NSW Independent  
Planning  
Commission

Pitt Street South  
OSD

INTERNAL AMENITY  
SUBMISSION

18 March 2021  
Final

### DEEP Issue #1:

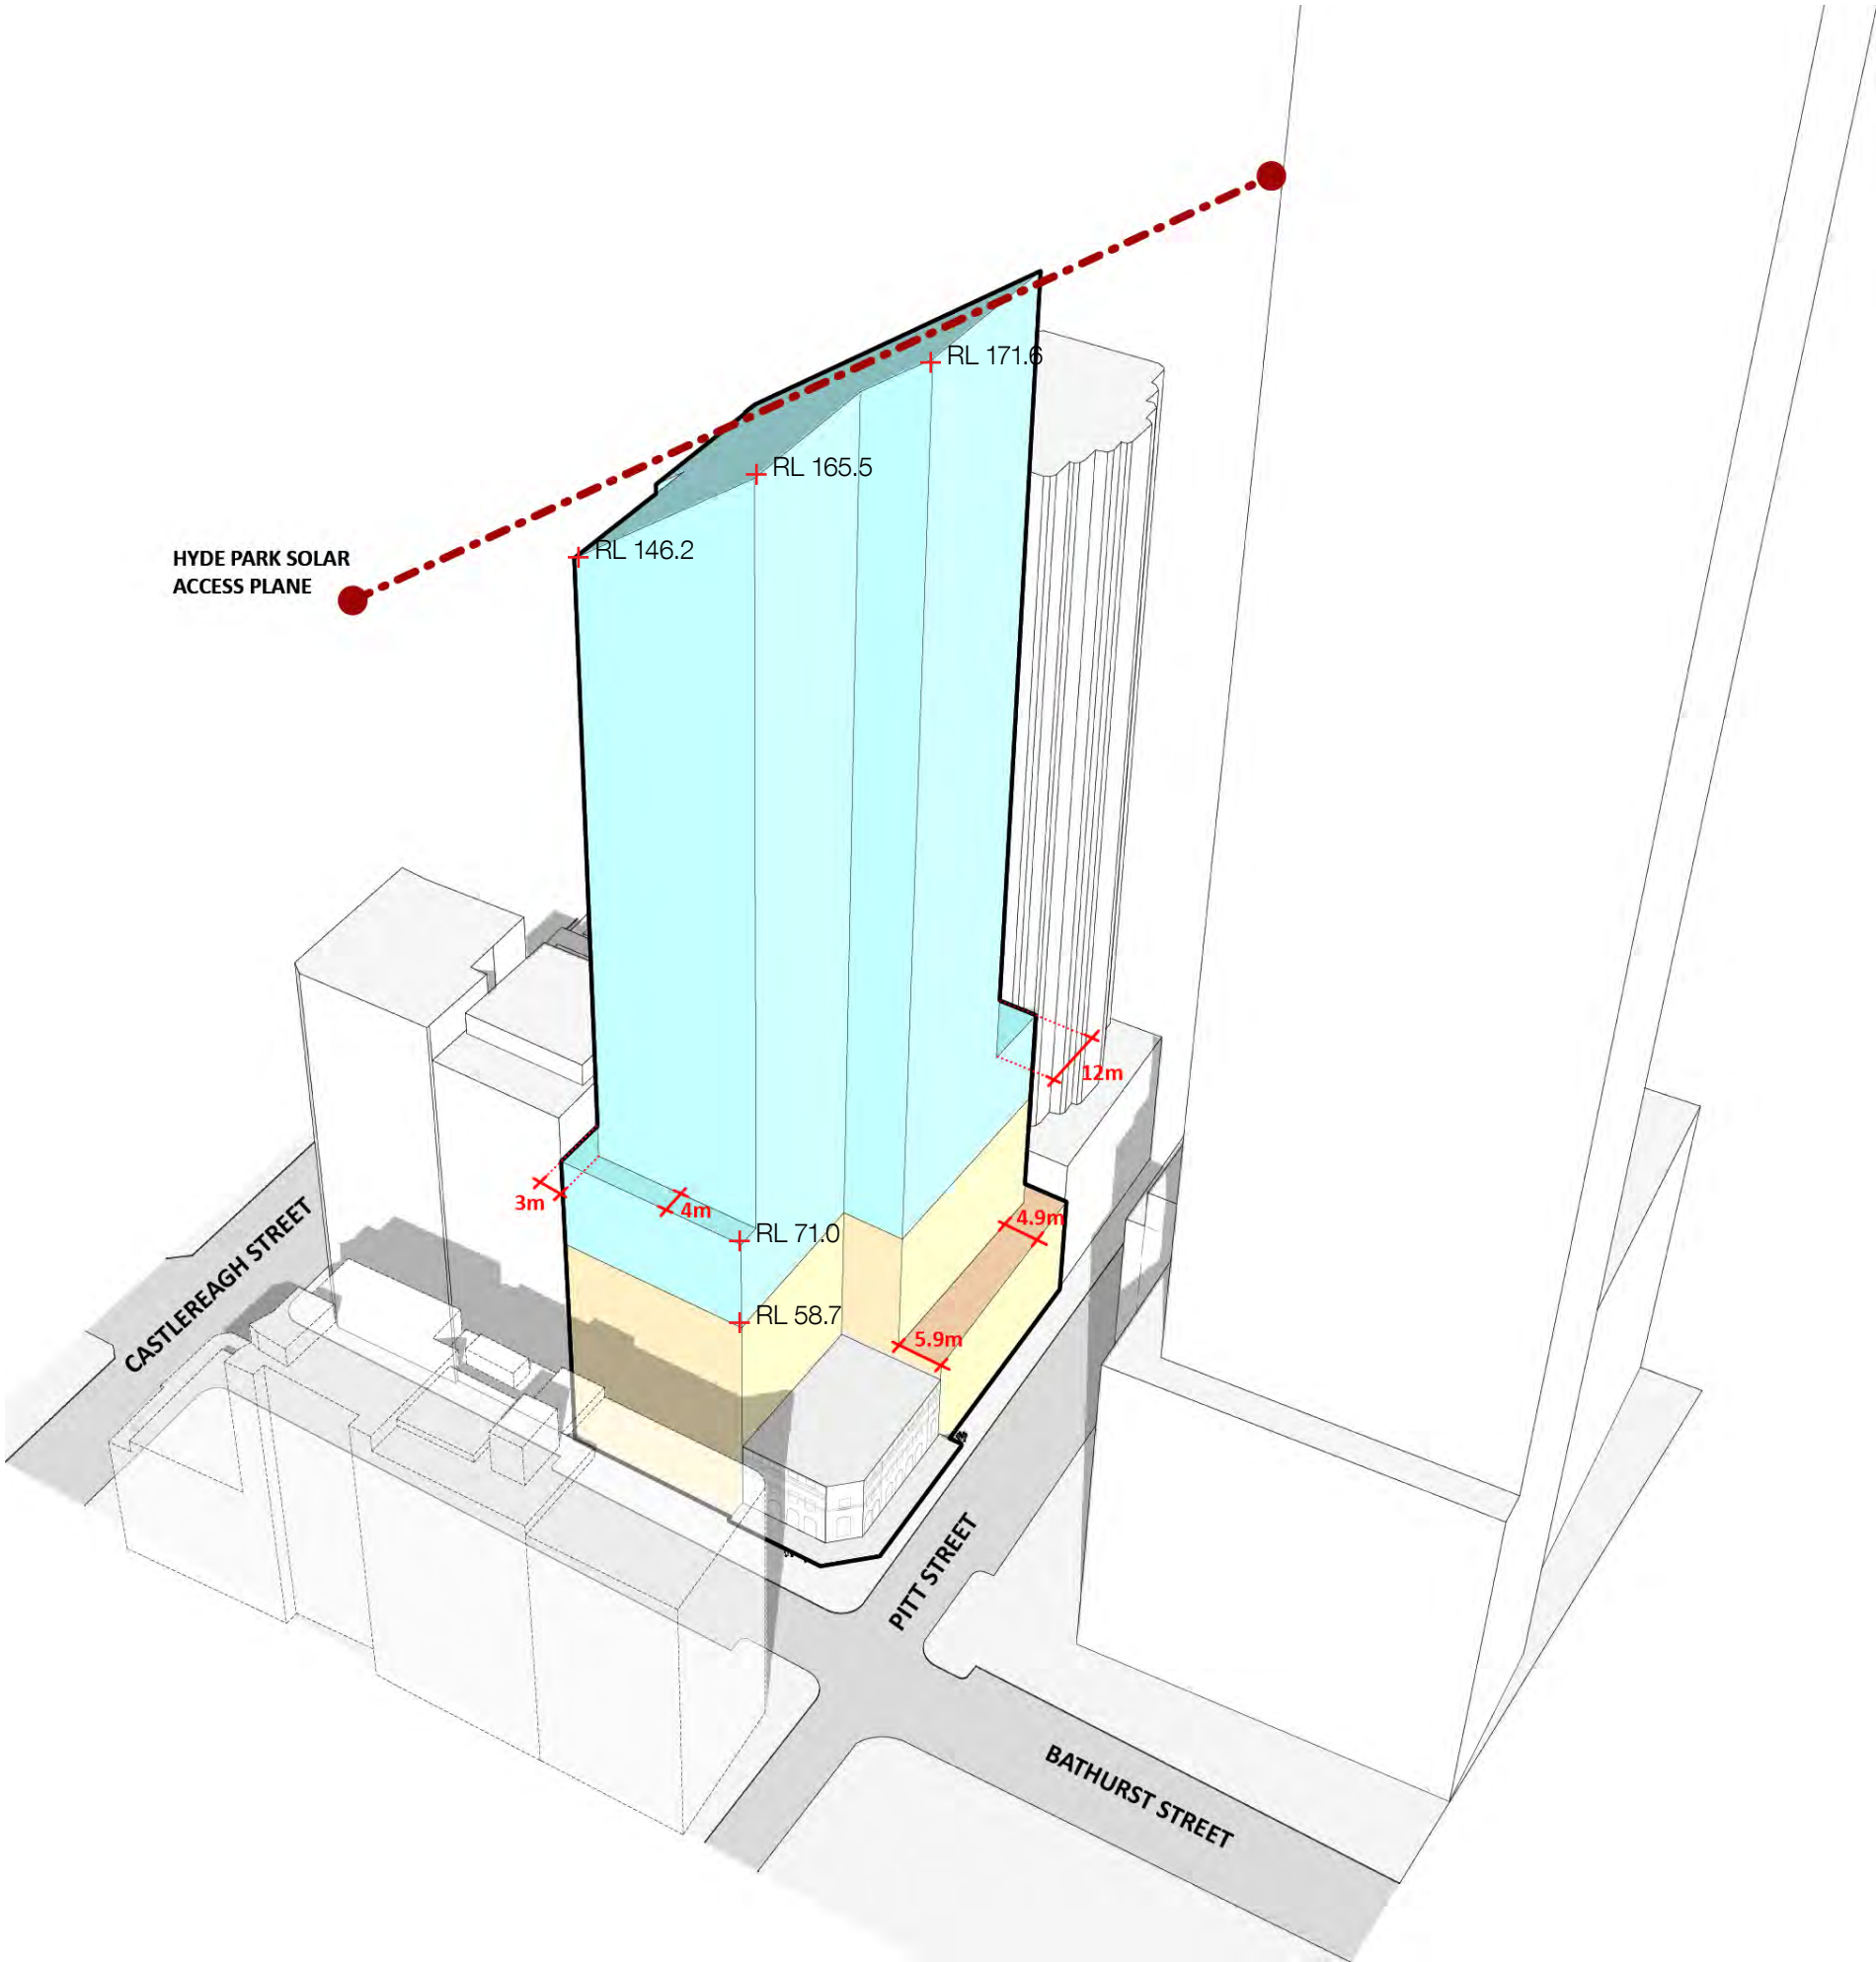
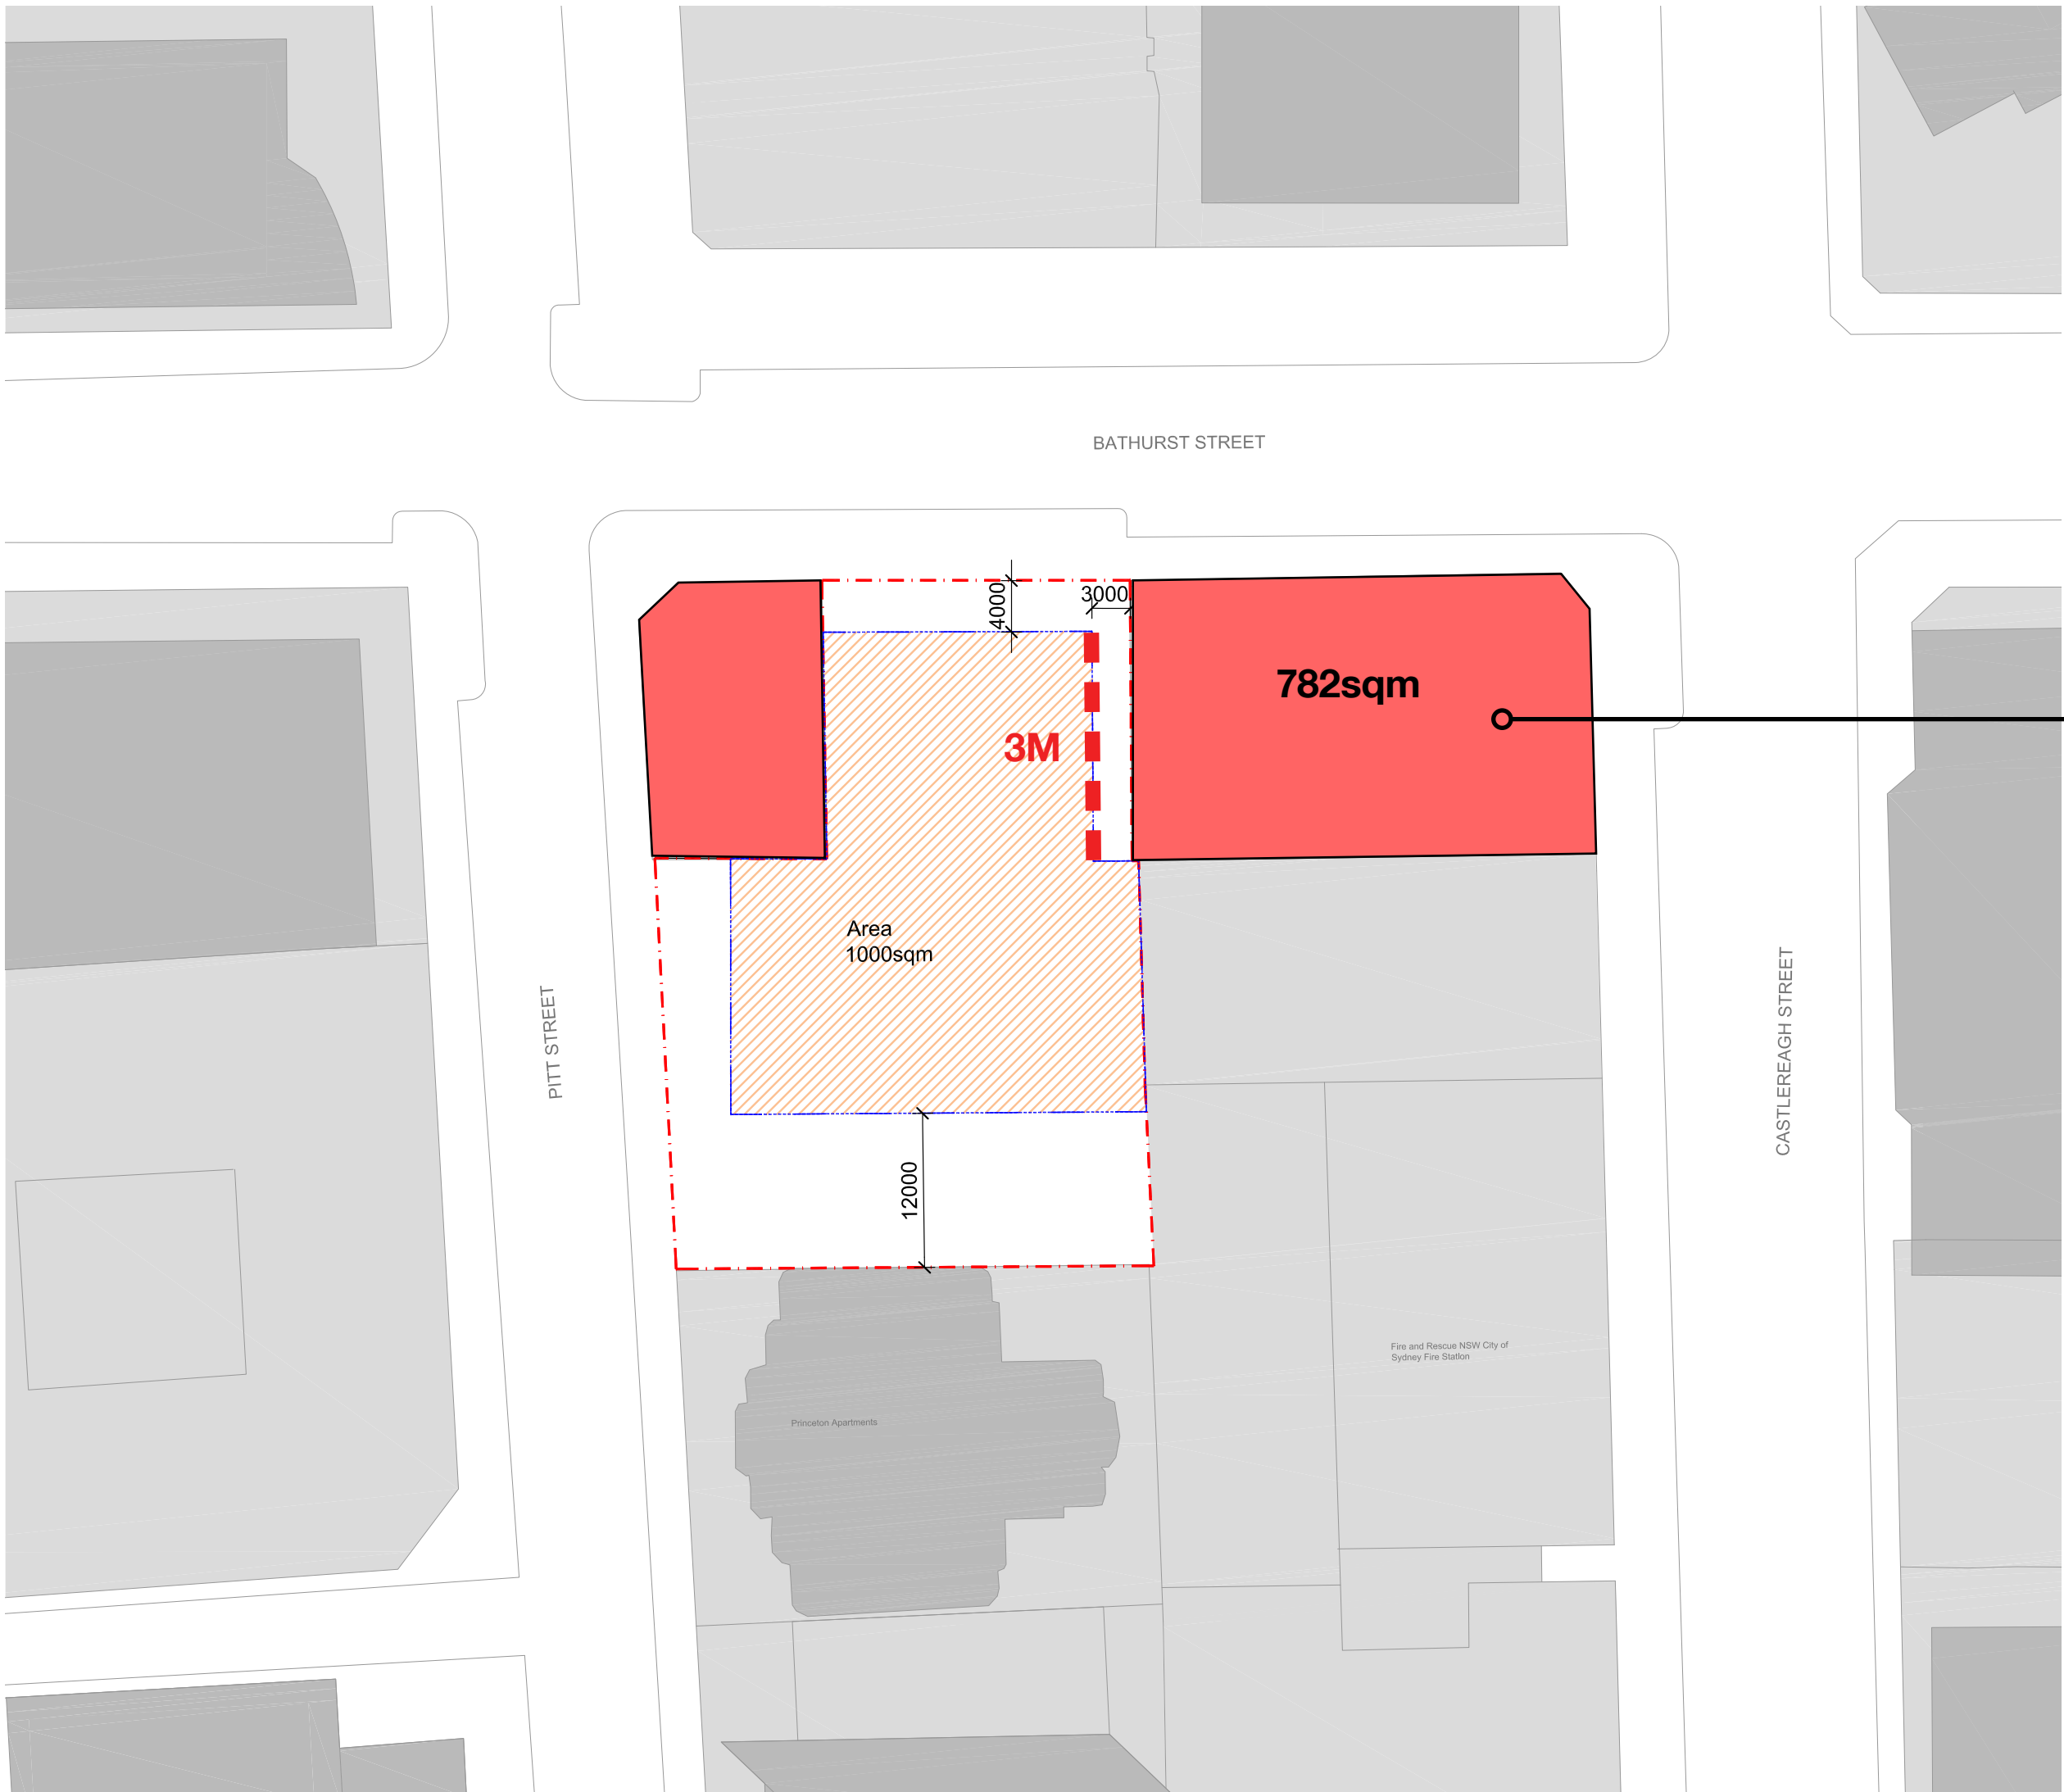
*The Panel raised concerns as to the significant challenges in choosing residential use on this site whilst also pursuing the maximum allowable envelope, noting that the concept design (SSDA) envelope does not distinguish between uses except regarding loading.*

*The design as presented does not satisfactorily achieve sufficient amenity to meet SEPP 65 ADG objectives. The scheme must demonstrate an approach to each boundary condition individually regarding the proposed use, specific conditions, controls and BCA compliance.*

### Response to DEEP Issue #1:

*We have thoroughly analysed the proposed design in relation to the SSDA envelope, BCA controls and and ADG requirements. The propsed design complies with the SSDA envelope setbacks. The design is also fully compliant with BCA light & ventilation requirements as well as BCA light and ventilation, building separation and visual privacy requirements. The proposed design also complies with ADG solar access and natural ventilation requirements, maximum number of apartments per floor and minimum apartment and private open space requirements.*
